Access Compliance Report Public Rights-of-Way (Curb Ramps)

Main Street: THALIA_ST		Cross Street: ARTISAN_ST		Location:	SE
ADA ID: RPRK211020165413	Ramp Type: Type 4 - Parallel	Initial Pass/Fail: Fail	Overall Compliance: No	Severity Score:	16
Codes/Mitigation Info/Possible Solution			Field Measurements/Component Compliance

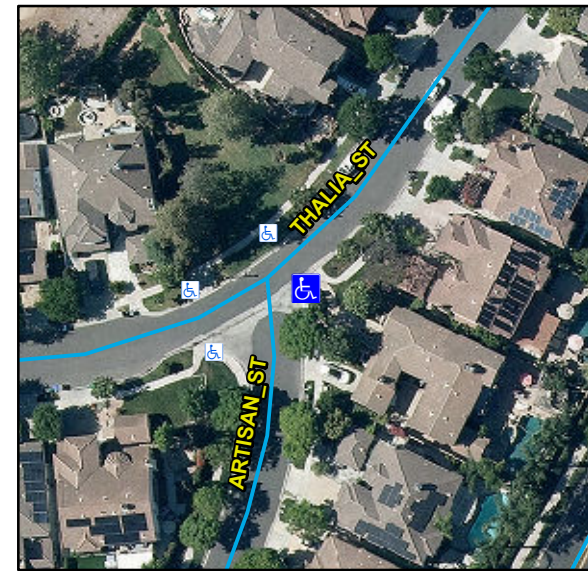
Compliance	Description	Data	Compliance	Description	Data
N/A	Ramp Length LT (in)	123	N/A	Ramp Length RT (in)	118
Yes	Ramp Width LT (in)	53	Yes	Ramp Width RT (in)	53
No	Ramp Run Slope LT (%)	10.5	Yes	Ramp Run Slope RT (%)	1.1
No	Ramp Cross Slope LT (%)	2.3	No	Ramp Cross Slope RT (%)	4.4
N/A	Landing Present	N/A	N/A	DWS Provided	N/A
N/A	Landing Length (in)	N/A	N/A	DWS Contrast	N/A
N/A	Landing Width (in)	N/A	N/A	DWS Length (in)	N/A
N/A	Landing Run Slope (%)	N/A	N/A	DWS Full Width	N/A
N/A	Landing Cross Slope (%)	N/A		DWS Offset Type	N/A
N/A	Landing Movement Obstructed?	N/A	N/A	DWS Offset Left (in)	N/A
	Landing Movement Type	N/A	N/A	DWS Offset Right (in)	N/A
N/A	Landing Shared	N/A			
N/A	Clear Space	Yes			
N/A	Clear Space To Crosswalk (in)	N/A			
N/A	Marked Crosswalk 1	No	N/A	Marked Crosswalk 2	No
	Crossing 1 Direction	NW		Crossing 2 Direction	SW
	Marked Crosswalk 1 Width (in)	N/A		Marked Crosswalk 2 Width (in)	N/A

Remove & Replace Curb Ramp With Two New Directional Ramps or Equivalent.
